GM 9T60/9T65
MOMENTARY NEUTRAL

Figure 2

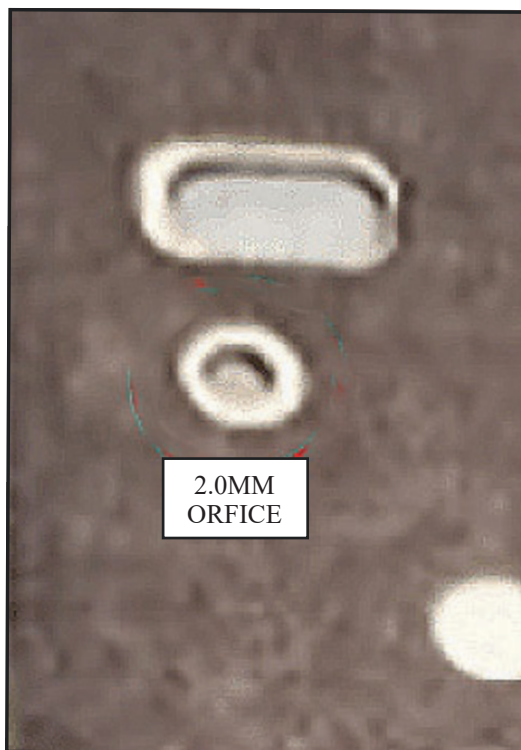
CORRECTION: Inspect the valve body spacer plate orifice shown in figure 1 for proper sizing. If the orifice is 0.5mm, replace the spacer plate using the part number listed under "Service Information". The updated spacer plate will have an orifice that measures 2.0mm as shown in figure 2

Valve Body To Transmission Case Spacer Plate With 2.0MM Orifice.....24292010
Updated spacer plate part number listed is for the 9T45, 9T50 and 9T60

Valve Body To Transmission Case Spacer Plate With 2.0MM Orifice.....24292011
Updated spacer plate part number listed is for the 9T65
